ADDENDUM NO. 1

The following attached changes are incorporated into requirements for the Project No. 33-NBC-1008 Contract Documents by this Addendum:

33-NBC-1008 NB Pump Lateral Lining Project _ 2026-27 Reach 2

NORTH BRANCH PUMP LATERAL
LINING PROJECT

C-110

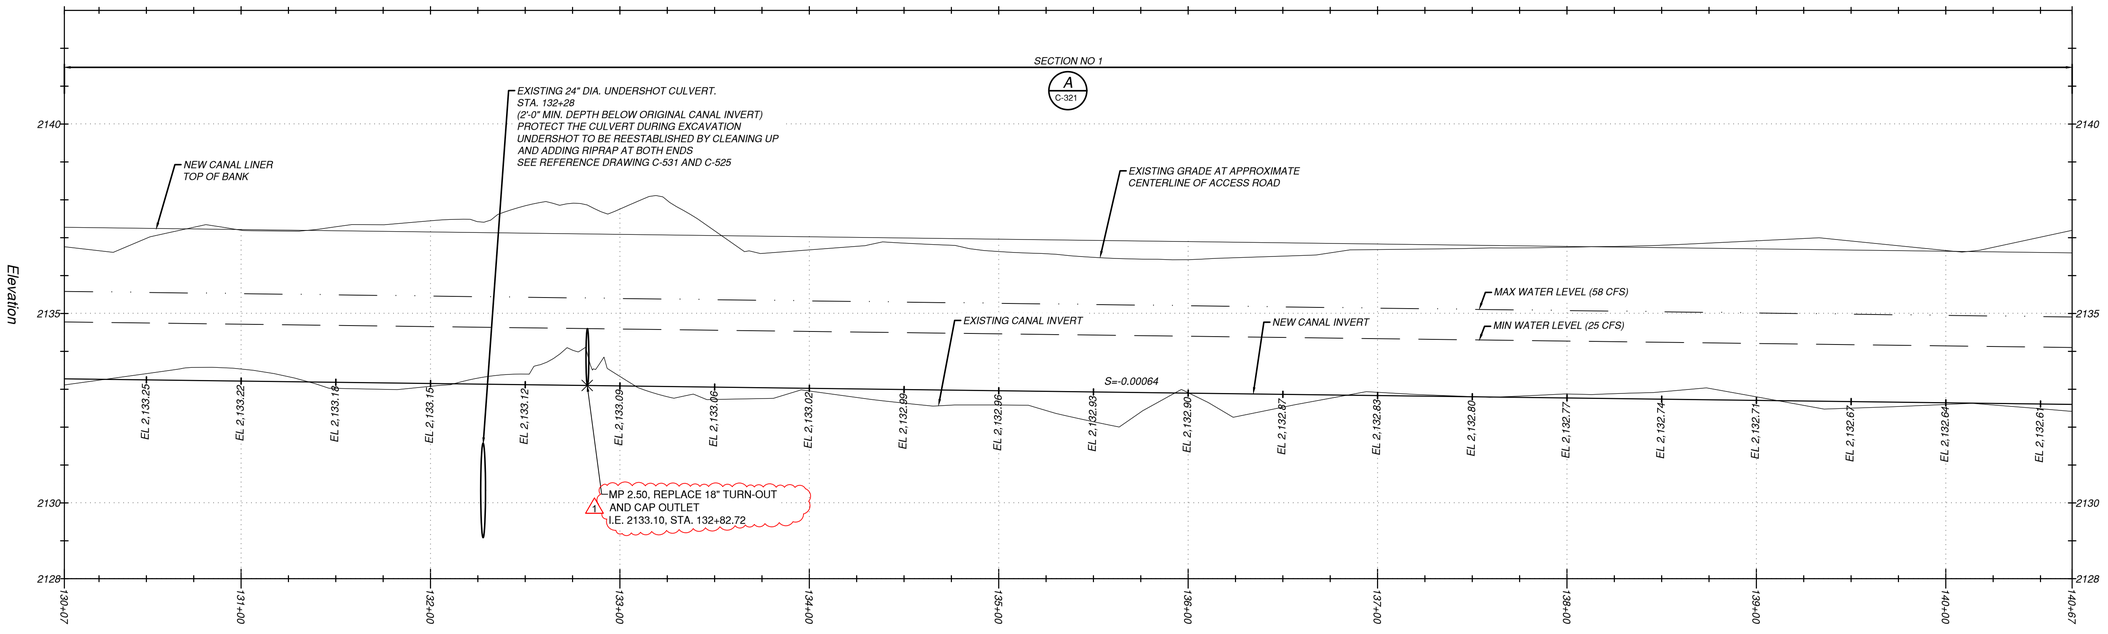
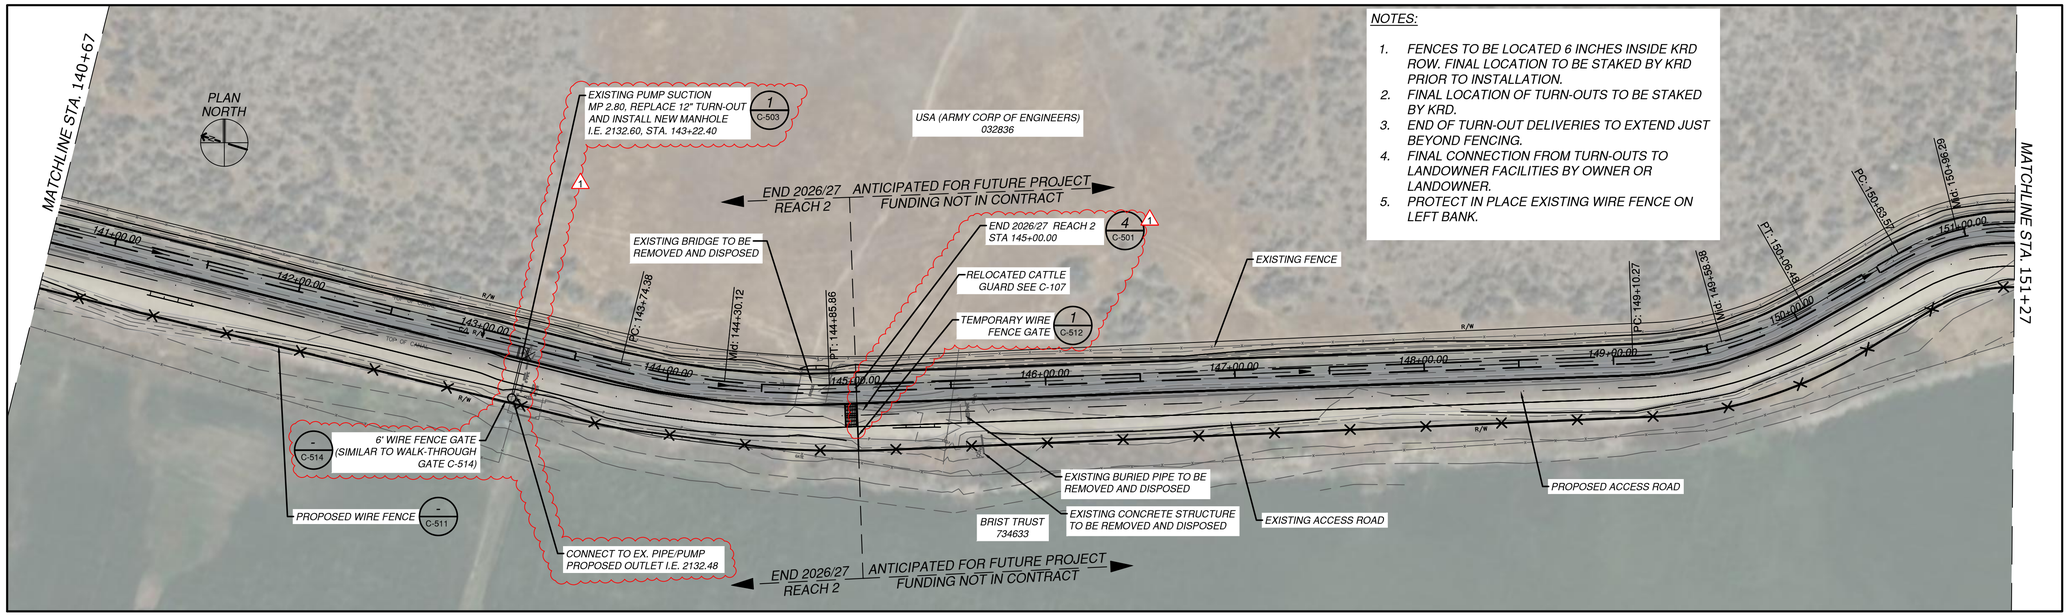
Q3. Can Morrison Road be used as access and staging for this reach?

Contractor is cleared to use Morrison for access. Any additional staging (other than what is laid out on C-110) will need approval through the adjacent property owner (Brist). Any disturbed land outside of the roadway width will need to be restored to its previous state after project completion. Access road improvements shall be consistent with the roadway sections shown on sheet C-505.

C-402

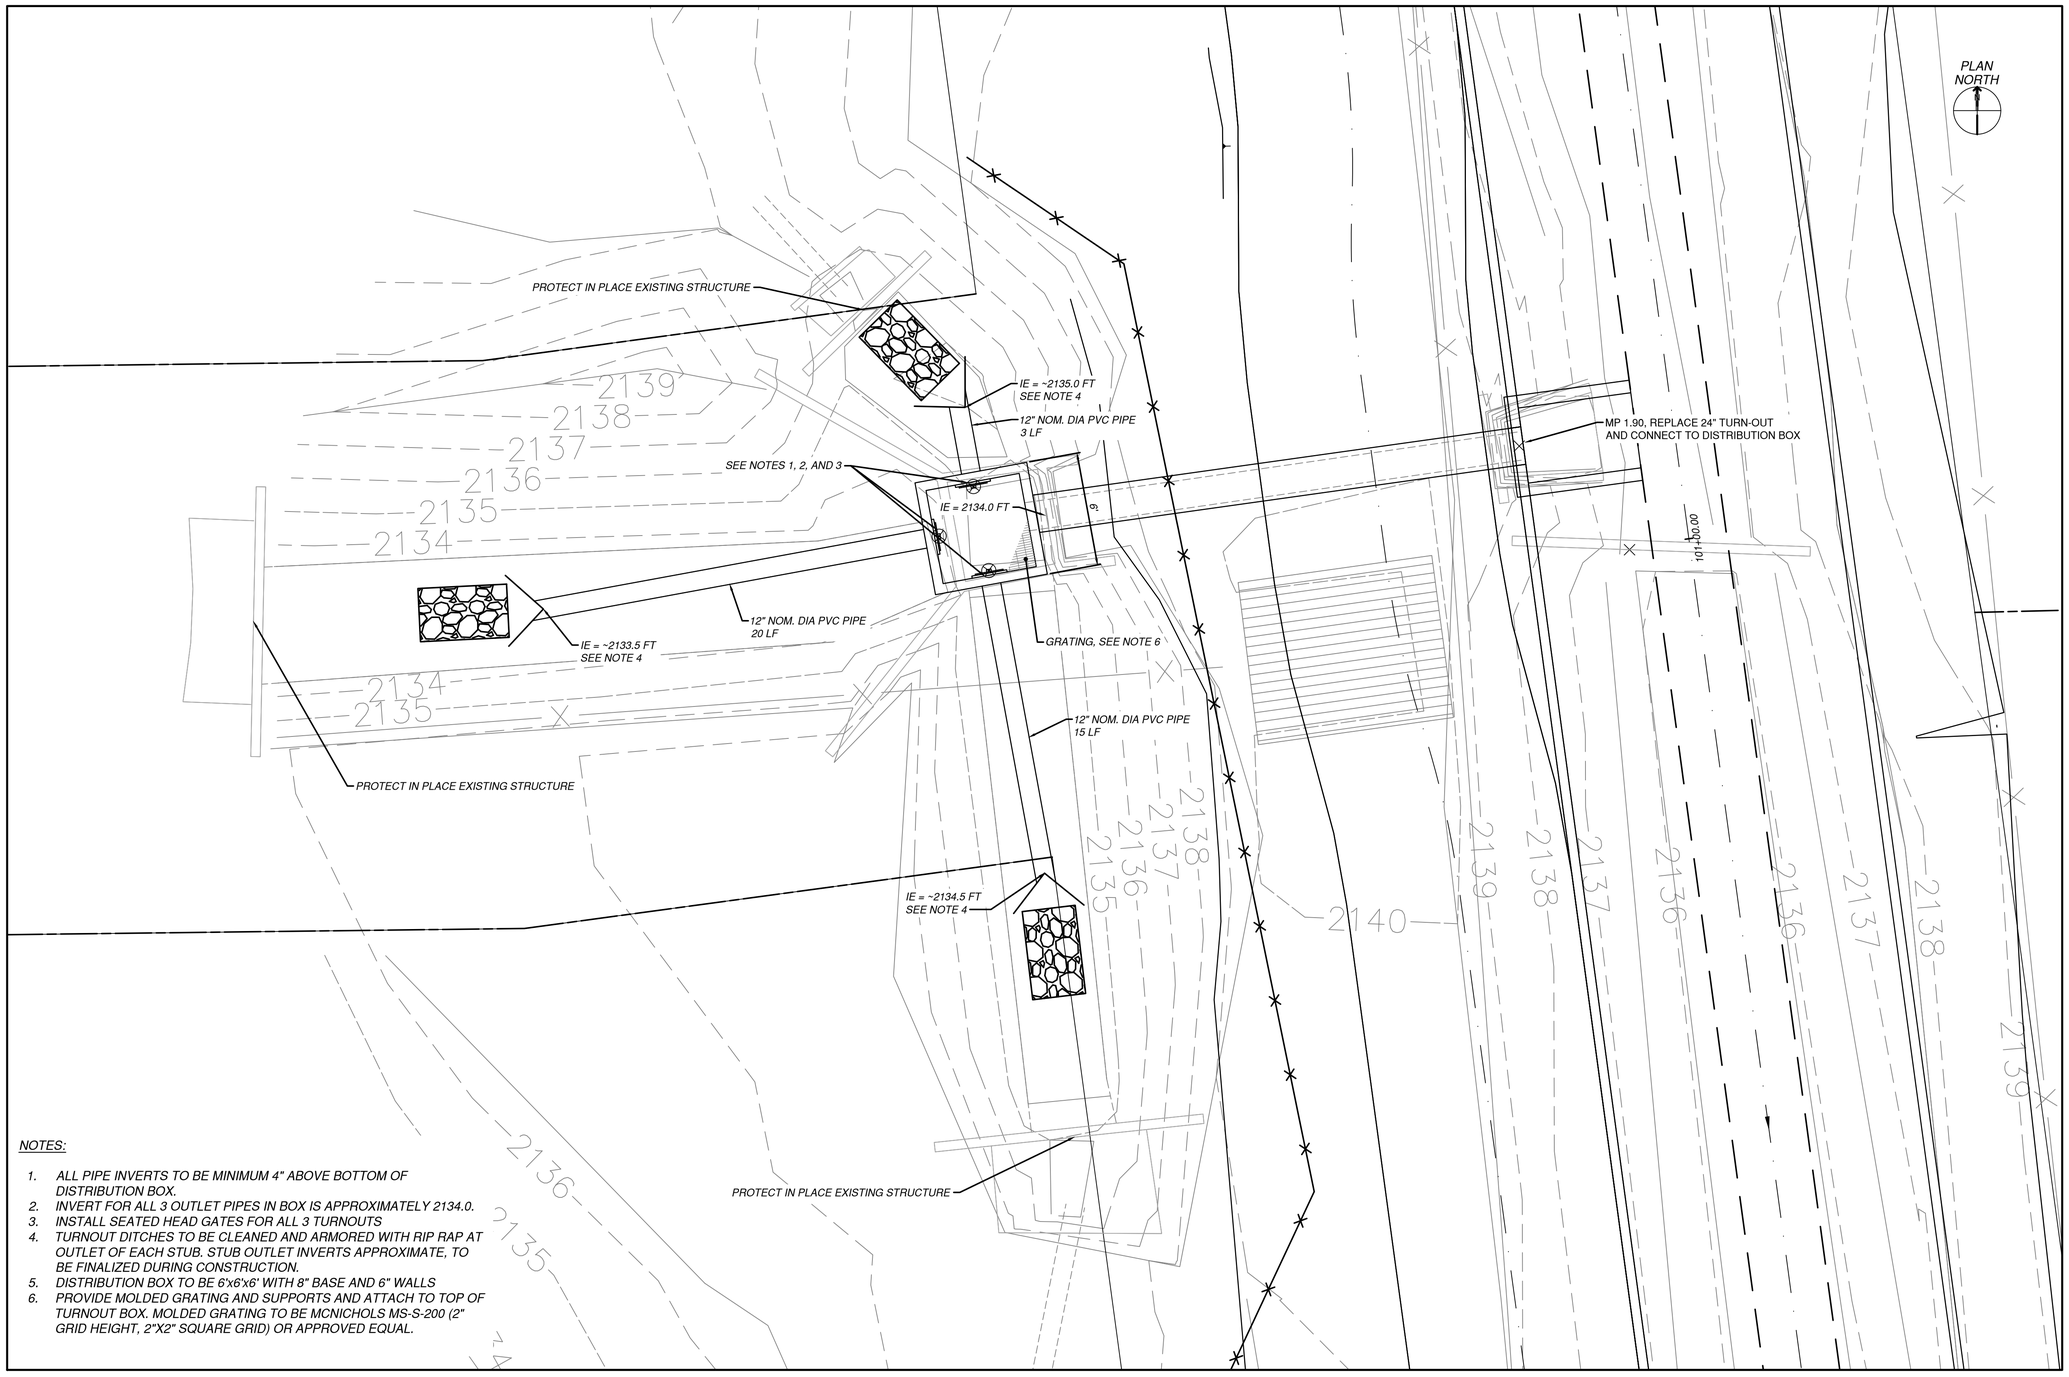
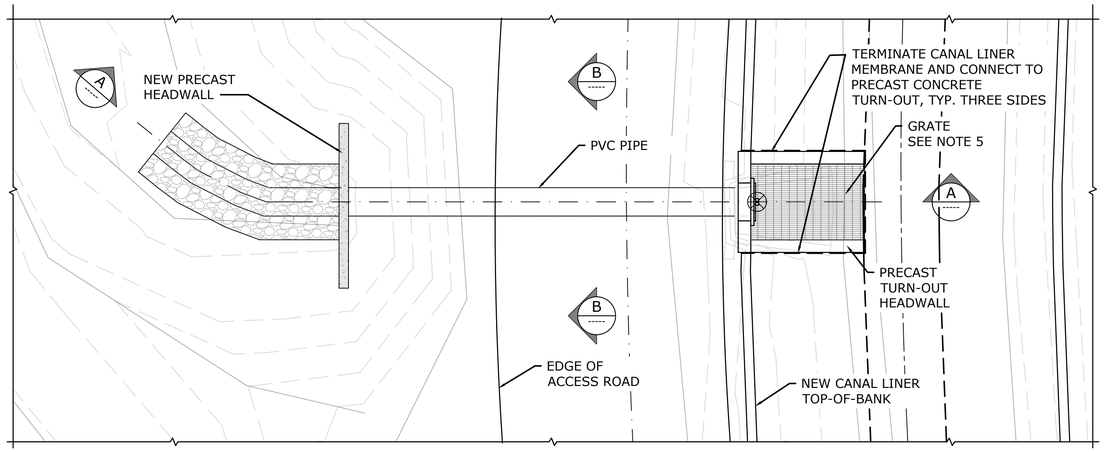
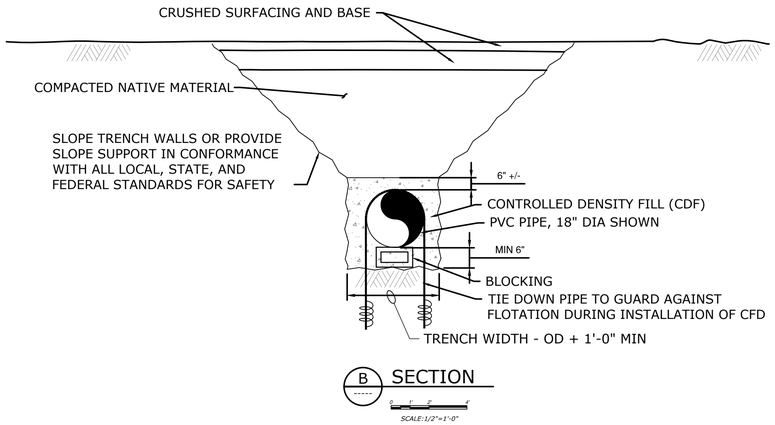
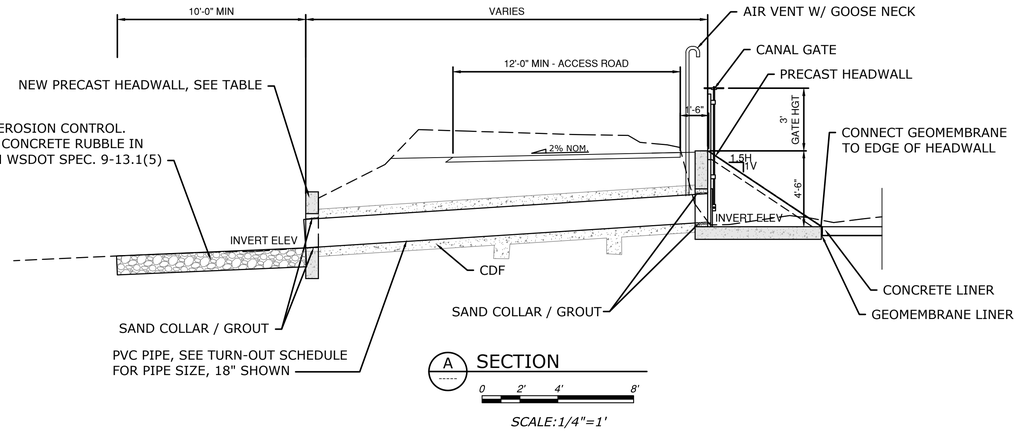
Attachment 2: Updated Section 00 41 00 - Bid Forms to update the turnout items, the wire gate quantity, add Morrison Road Access Improvements (item 315.1), and remove cattle guards from the bid schedule (item 360.1).

1. *ALL PIPE INVERTS TO BE MINIMUM 4" ABOVE BOTTOM OF DISTRIBUTION BOX.*
2. *INVERT FOR ALL 3 OUTLET PIPES IN BOX IS APPROXIMATELY 2134.0.*
3. *INSTALL SEATED HEAD GATES FOR ALL 3 TURNOUTS*
4. *TURNOUT DITCHES TO BE CLEANED AND ARMORED WITH RIP RAP AT OUTLET OF EACH STUB. STUB OUTLET INVERTS APPROXIMATE, TO BE FINALIZED DURING CONSTRUCTION.*
5. *DISTRIBUTION BOX TO BE 6'x6'x6' WITH 8" BASE AND 6" WALLS*
6. *PROVIDE MOLDED GRATING AND SUPPORTS AND ATTACH TO TOP OF TURNOUT BOX. MOLDED GRATING TO BE MCNICHOLS MS-S-200 (2" GRID HEIGHT, 2"X2" SQUARE GRID) OR APPROVED EQUAL.*

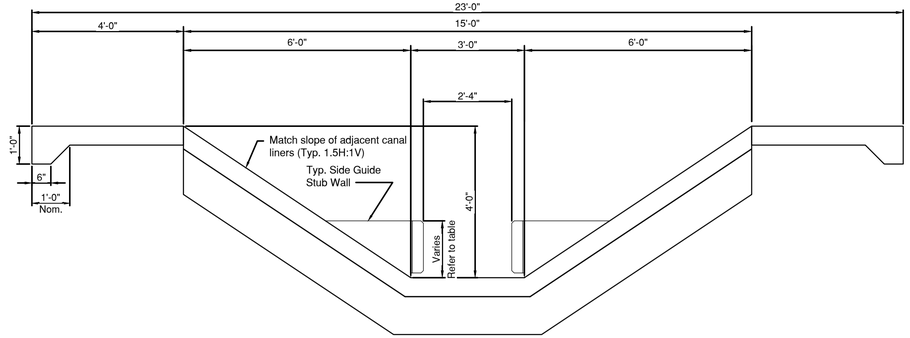
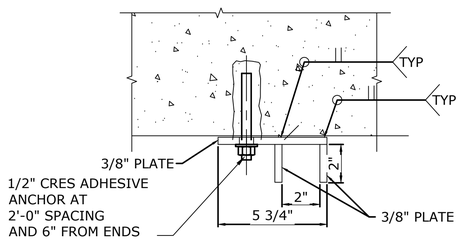
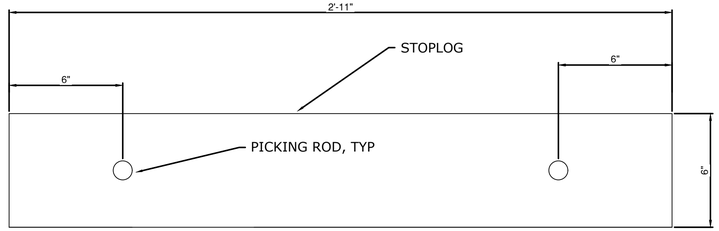
Q2. Can aluminum stop logs be used instead of stainless steel?

It is acceptable to use aluminum stop logs; however, they must be 1-1/2 x 6 inch tubes to be consistent with stop log sizing at other locations on KRD projects. See sheet C-507 in Attachment 3.
